Artificial Island Open Window Concerns re: Dominion Proposal 1A

PSE&G Electric Delivery Planning

Dominion Proposal No. 1A

Constructability Concerns – Line Configuration

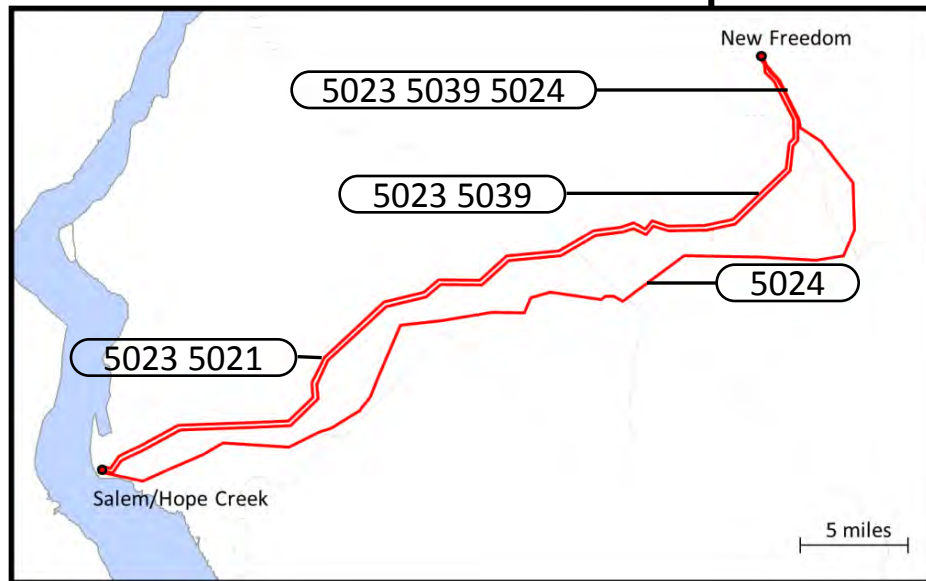
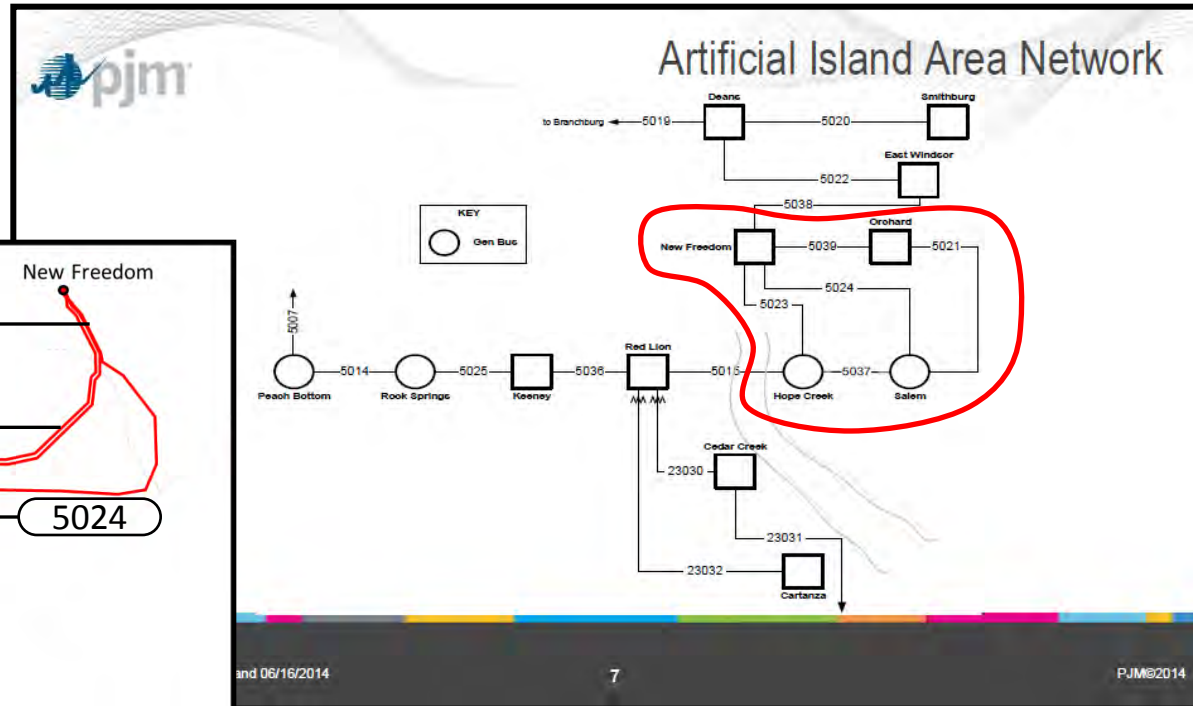
- Constructability and design appear not to reflect physical layout
 - 5023 & 5024 are not parallel as shown in the associated one-line but rather are separated by 5039.
 - Alternatives include a highly undesirable 500kV line crossing, two full stations opposite of 5039, or significantly greater facility size to resolve this separation.
 - Outage impacts of alternatives would be deterring.

Sensitivity on Percent Series Compensation

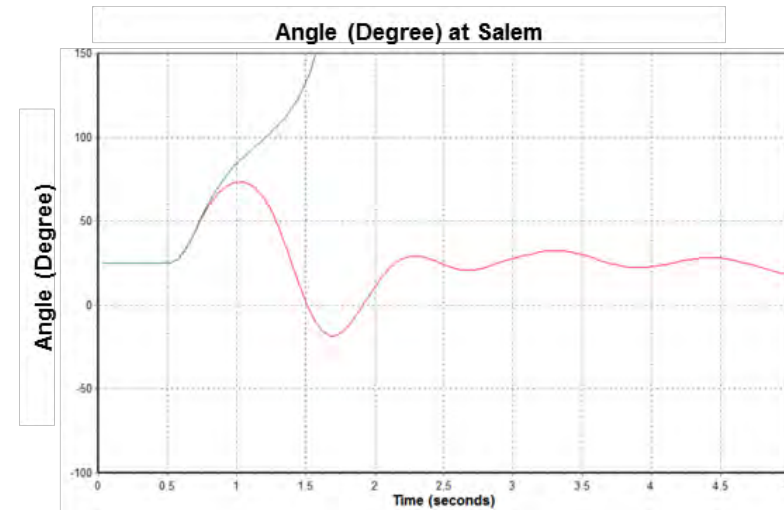
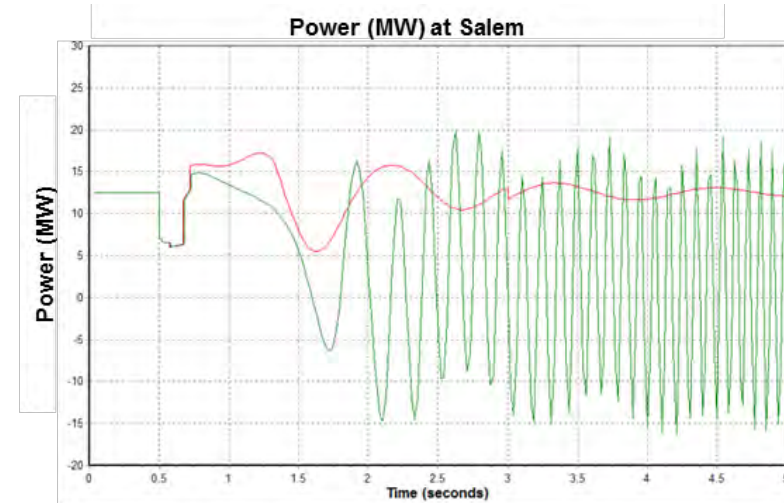
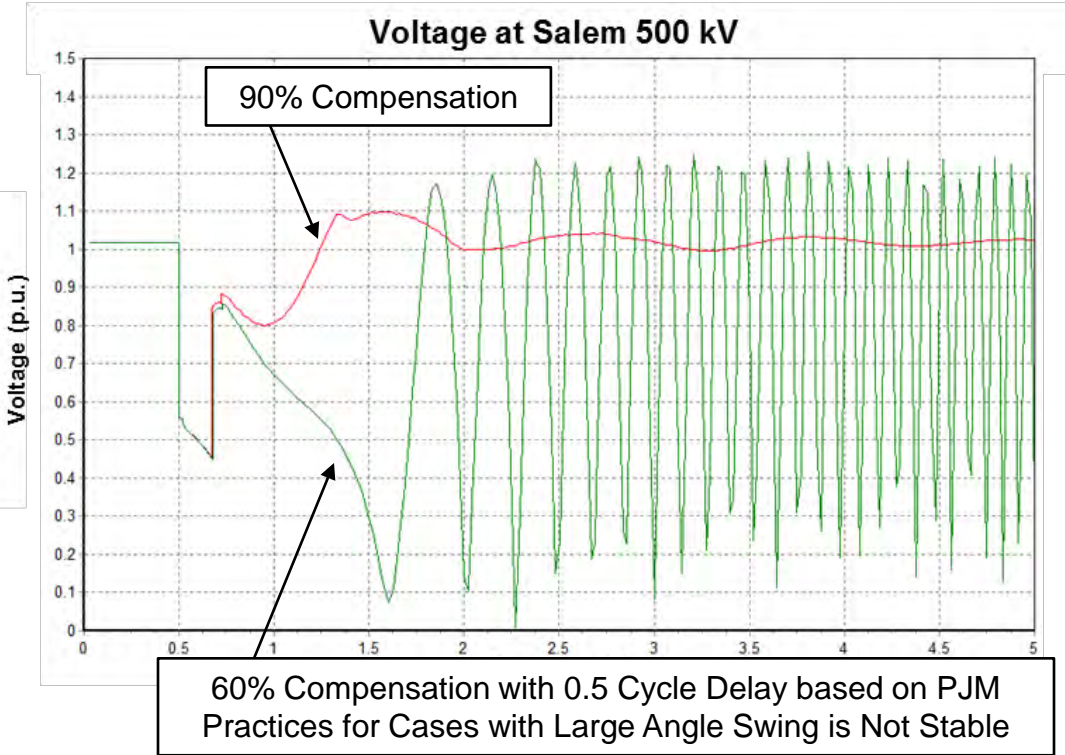
MEPPI examined Series Compensation of 60%, 70%, 80%, and 90%

Stability simulations modeled TCSC at a fixed 90% compensation without modulation. Lower compensation/modulation may lead to system instability.

40% COMPENSATION

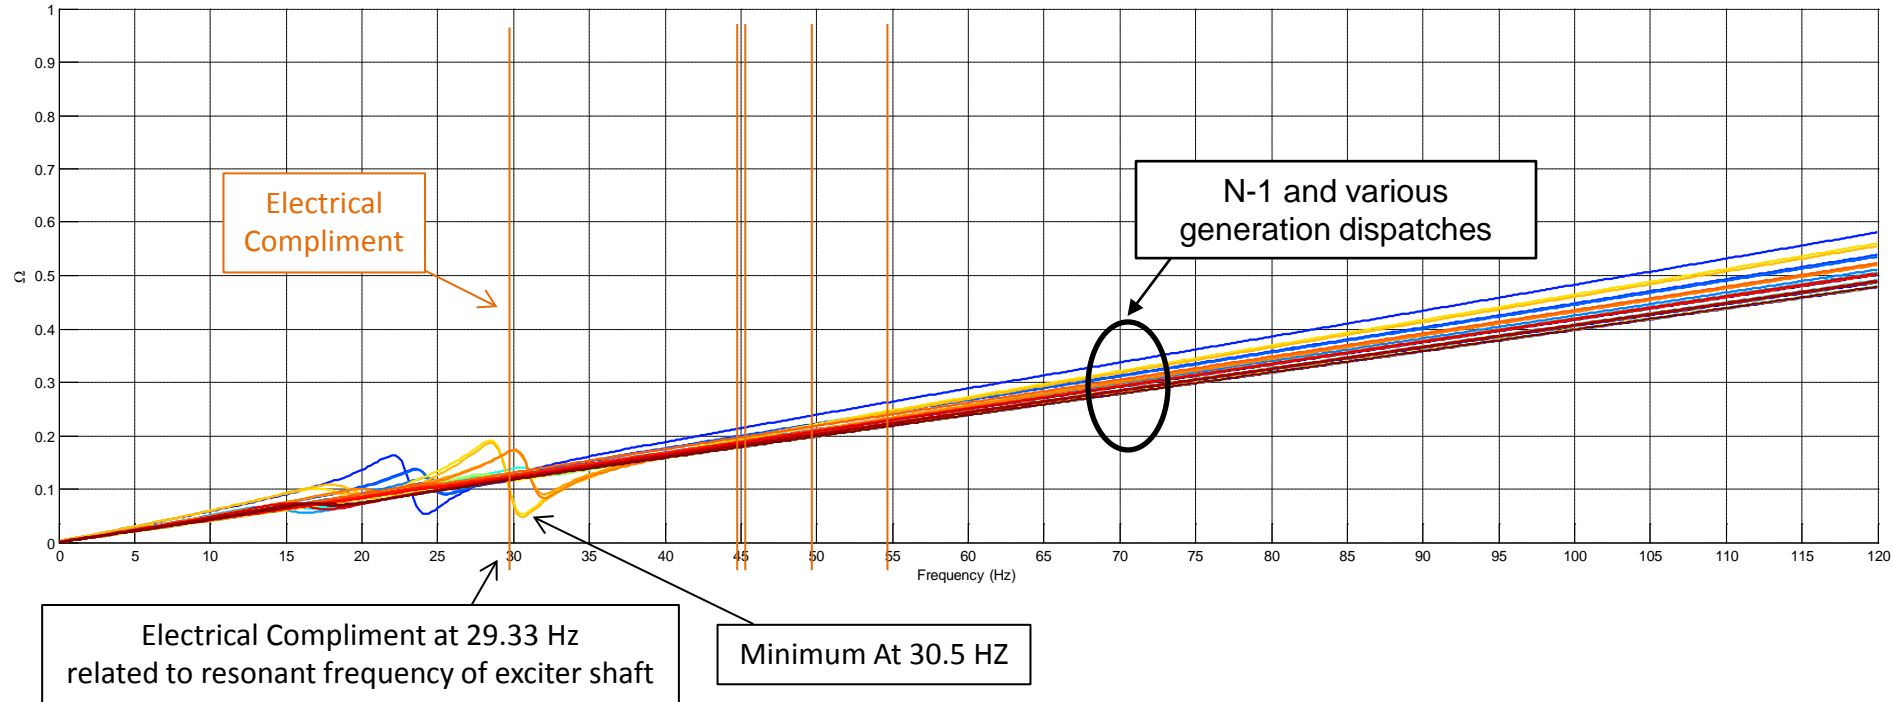
The results show:

- There are interaction and SSR problems associated with 40% compensation that may cause serious damage to AI units.
- N-2, N-3 ... circuit outage results are expected to show more/severe concerns.
- It is recommended that up to N-5 outages be studied, since these analyses could not be readily done in time.

90% COMPENSATION

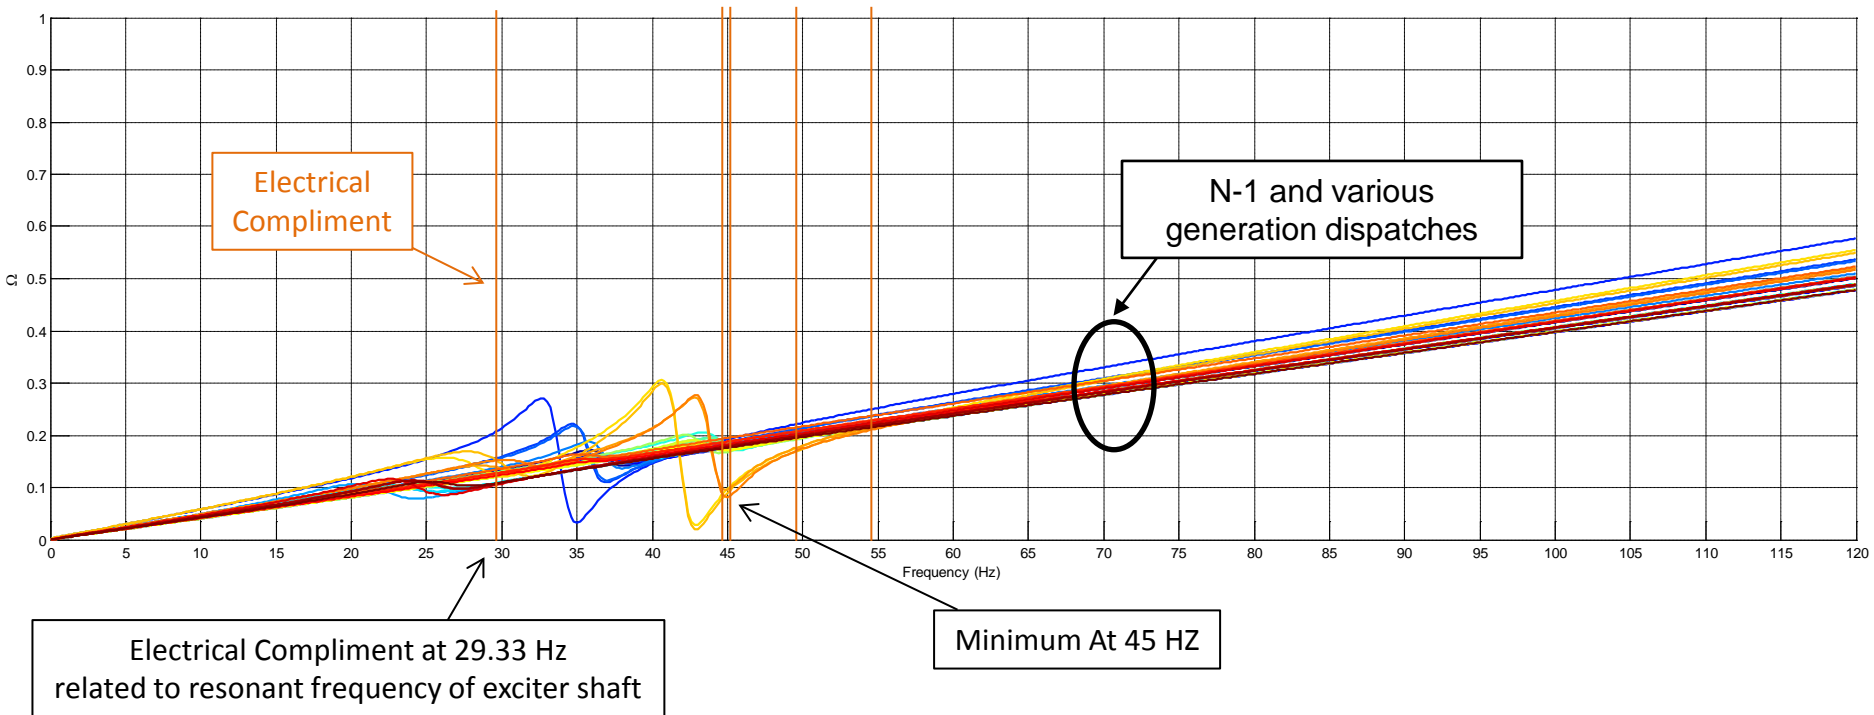
The results show:

- There are interaction and SSR problems associated with 90% compensation that may cause serious damage to AI units.
- N-2, N-3 ... circuit outage results are expected to show more/severe concerns.
- It is recommended that up to N-5 outages be studied, since these analyses could not be readily done in time.
